# Access Compliance Report Public Rights-of-Way (Curb Ramps)

Main Street: PACIFIC\_AVE Cross Street: DESSER\_LN Location: NW

ADA ID: RPRK210922121221 Ramp Type: Type 1 - Perpendicular Diagonal Initial Pass/Fail: Pass Overall Compliance: No Severity Score: 22

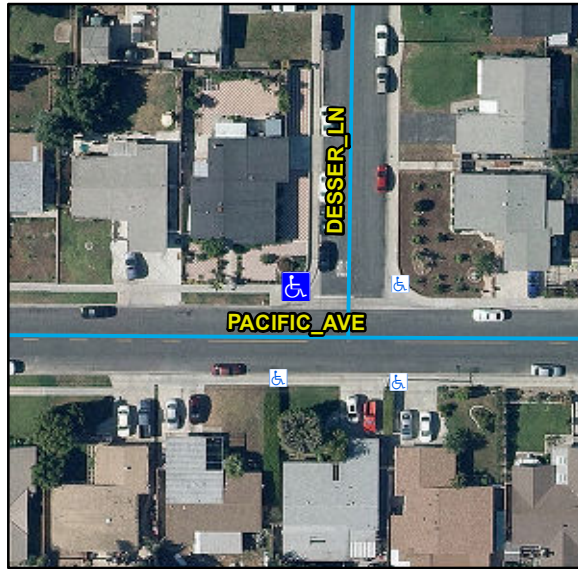
R304.2.2, R304.2.1, R304.2.2-Perp, R304.3.2-Para, R304.5.3, R304.2.3, R305, STD 1115

| Compliance | Description                           | Data | Compliance | Description                   | Data   |
|------------|---------------------------------------|------|------------|-------------------------------|--------|
| No         | Landing Width (in)                    | N/A  | No         | Flare Slope RT (%)            | 11.3   |
| No         | Landing Cross Slope (%)               | N/A  | No         | DWS Provided                  | No     |
| Yes        | Gutter Ponding                        | No   | No         | Curb Slope                    | 9.2    |

Remove & Replace Curb Ramp With Two New Directional Ramps or Equivalent.
